Department of Energy

**Program Plan for Analysis of Shear Wave Velocity Data to Address Uncertainties in
Estimates of Hanford Ground Motion Waste Treatment Project**

August 27, 2004

Figure 1. Location of Geologic Profile (on next page) from the IDF site through the WTP site.

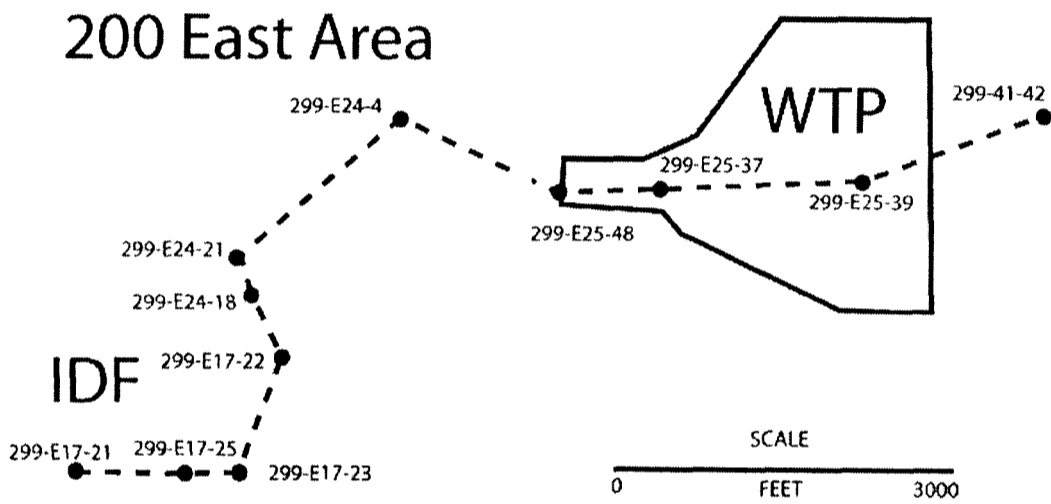
Issue #1: *Comparison of the geology and the intervening paleo-channel between the Integrated Disposal Facility (IDF) site and the WTP site; the overall thickness of soil (depth to bedrock); the thickness of individual soil layers (Hanford and Ringold formations); V_s for all layers (soil, basalt bedrock, sedimentary interbeds); and potential lateral variation in V_s .*

The detailed supra-basalt (sediment above the basalt) geology in the area surrounding and within the WTP site will be assembled and presented, using data from numerous boreholes that have been drilled and logged as part of the IDF site (adjacent to WTP) and other previous studies in the nearby area (see Figure 1). These data provide the thickness of each individual soil layer in the Hanford and Ringold formations, and depth to basalt bedrock, at numerous geographic locations surrounding and within the WTP site. Lateral variations in some of the lower sedimentary layers (Ringold formation), such as the paleo-channel that lies between the IDF site and the WTP site are known, but the sedimentary structures outside of this erosional channel are the same as those at the IDF and WTP sites, and addition to other nearby locations outside of this erosional channel. The paleo-channel does not affect the structure within the basalt sequence (see Figure 2).
